**ATTACHMENT 2 TO TXX-06125**  
**RESPONSES TO REQUESTS FOR ADDITIONAL INFORMATION**  
**FOR THE REPLACEMENT STEAM GENERATOR SUPPLEMENT**  
**TO TXU POWER'S OTHER THAN LOSS OF COOLANT**  
**ACCIDENT ANALYSIS METHODOLOGIES**

**July, 2006**

Figure 2-1. Comparison of  $\Delta 76$  design parameters – Total Secondary Side Mass

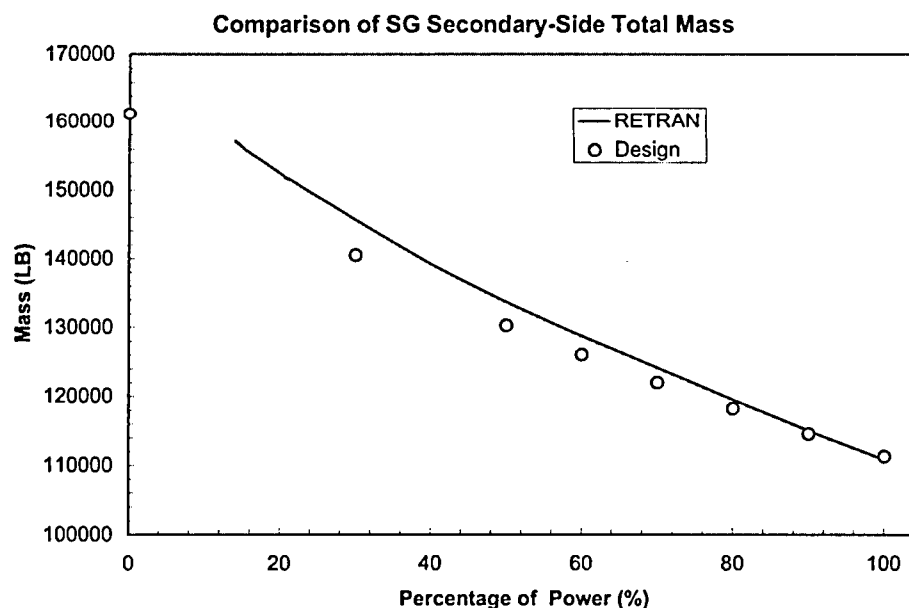
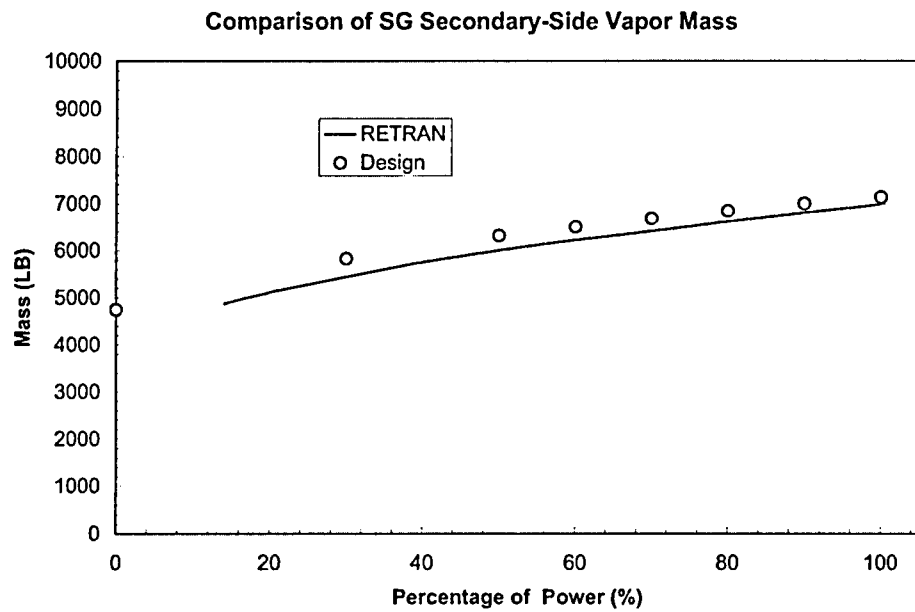
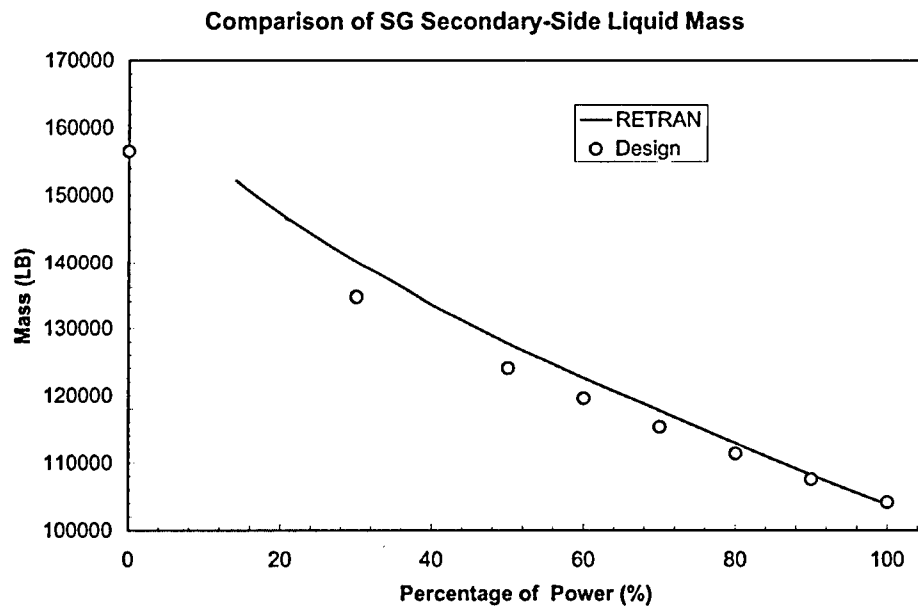
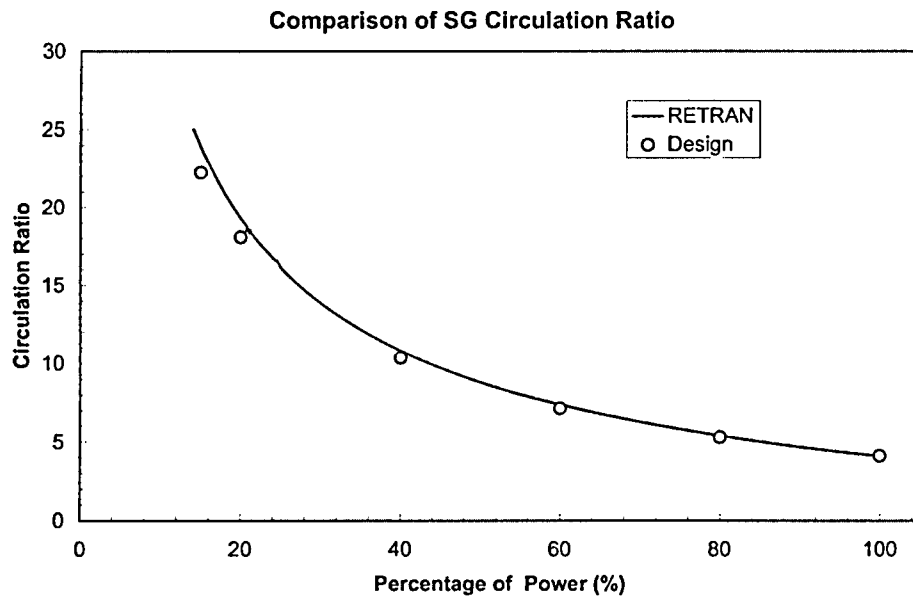
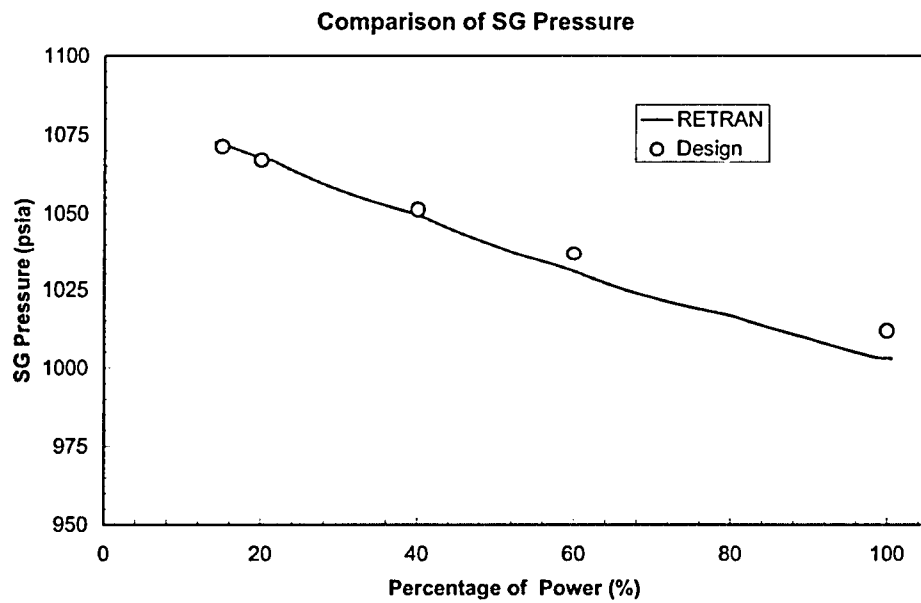
- a. Provide the vendor design data and model results that were used to validate the model's ability to reproduce steady-state conditions. Charts and tables are acceptable.**
- b. Explain what evidence provides reasonable assurance the model will accurately reproduce transient conditions at CPSES.**
- c. Given the differences in design and modeling between the D-4 and  $\Delta 76$  steam generators, the staff believes comparing the results of the two sets of analyses is problematic and may not be a true evaluation of the new modeling and methodology. Please provide comparisons of  $\Delta 76$  steam generator analysis to those of similar design and size.**

- a. The data in the Table 2-1 is a summary of a comparison of relevant design data from the vendor's design tool and the RETRAN-02-based stand-alone  $\Delta 76$  SG model for full power, steady-state operating conditions. As may be observed, the results from the full power RETRAN-02 stand-alone model compare quite well to the vendor-supplied design data.**

Additional evaluations were then performed to assess the adequacy of the model for conditions other than full power operations. Forcing functions for the Reactor Coolant System flow rate and hot leg temperature and the main feedwater flow rate and temperature were used with the stand-alone steam model to simulate a gradual downpower transient. Design data at various power levels were extracted from design input data provided by the vendor specifically for this purpose. Comparisons of relevant parameters are presented in Figures 2-1 through 2-5. As may be observed, the stand-alone  $\Delta 76$  steam generator model provides an adequate representation of vendor-supplied design data throughout the range of normal operating conditions.

Figure 5-1. Comparison of results for an increase in feedwater flow transient with  $\Delta 76$  and D4 steam generator designs – normalized reactor power

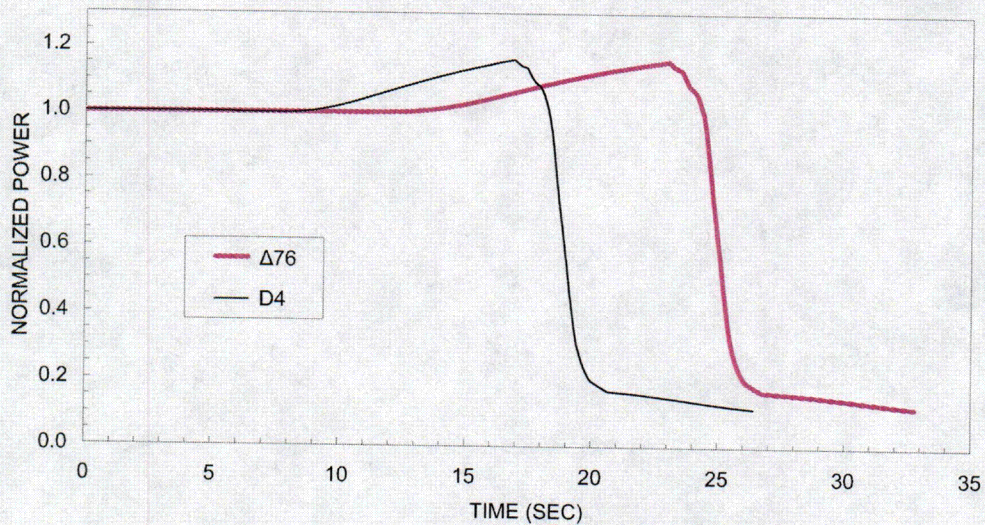
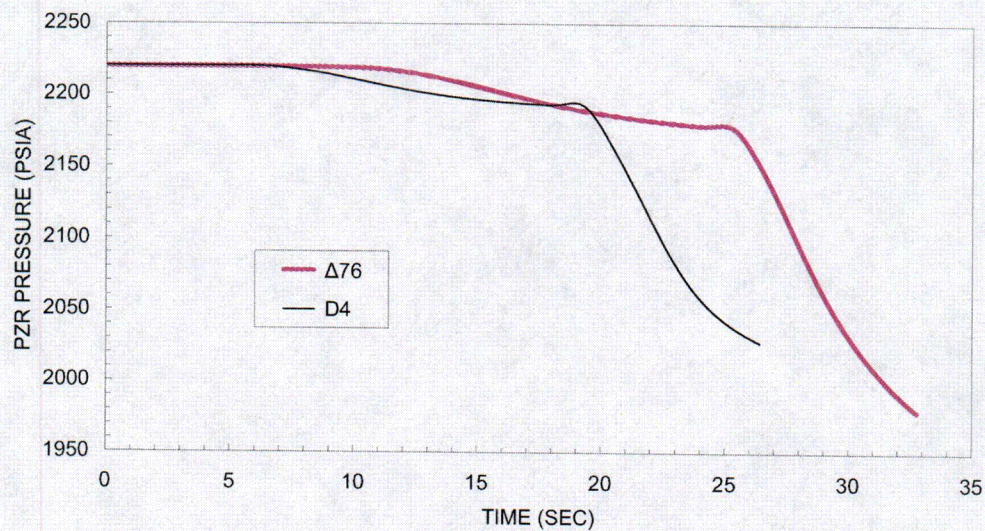
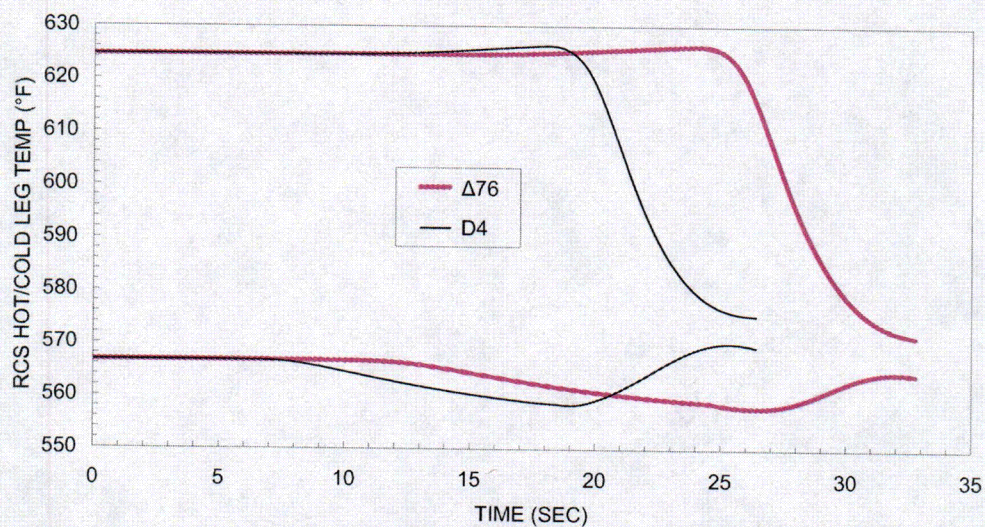
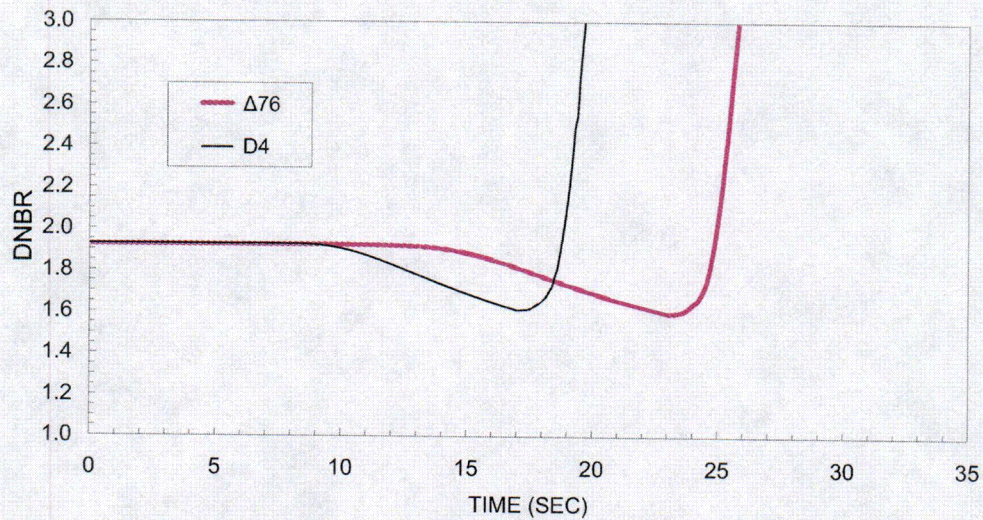
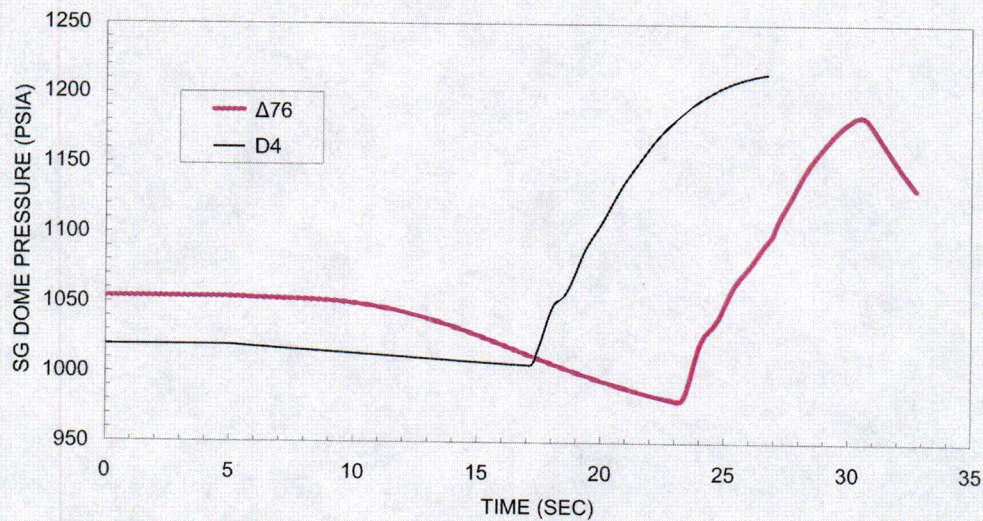
In Section 3.3 of ERX-04-005 (Ref. 2) the licensee provides a qualitative discussion of the impact of the  $\Delta 76$  steam generator on the Non-LOCA transients. The licensee repeatedly uses the statement, "The incorporation of the  $\Delta 76$  steam generator design does not result in a transient response that is significantly different from the current CPSES analyses." Given the responses to RAI Questions 1 and 3 for RXE-91-001-A the staff would expect the potential for a significant difference in transients in which feedwater flow or temperature is affected. Given the differences in design and modeling between the D-4 and  $\Delta 76$  steam generators, the staff believes comparing the results of the two sets of analyses is problematic and may not be a true evaluation of the new modeling and methodology. To determine the adequacy of existing methodologies, provide a quantitative discussion of the impact of the  $\Delta 76$  steam generator on the Non-LOCA transients. Include how the transient progresses from start to finish.

A comparison of the Sequence of Events for these two analyses is provided in Table 5-1. Comparative plots of relevant parameters are shown in Figures 5-1 through 5-5. The same trends are observed in each analysis. The effects of the larger heat transfer area of the  $\Delta 76$  steam generator model are apparent in the initial conditions shown in Figure 5-5, where, for the same RCS average temperature, the steam generator secondary side pressure is higher.

As previously noted, the effects of the feedwater temperature decrease in the  $\Delta 76$  steam generator design lag the effects seen with the D-4 steam generator design. The rate of power increase is faster in the D-4 analysis, resulting in a slightly higher overshoot in the reactor power between the time the overpower reactor trip setpoint is reached and control rods begin to drop into the reactor core.
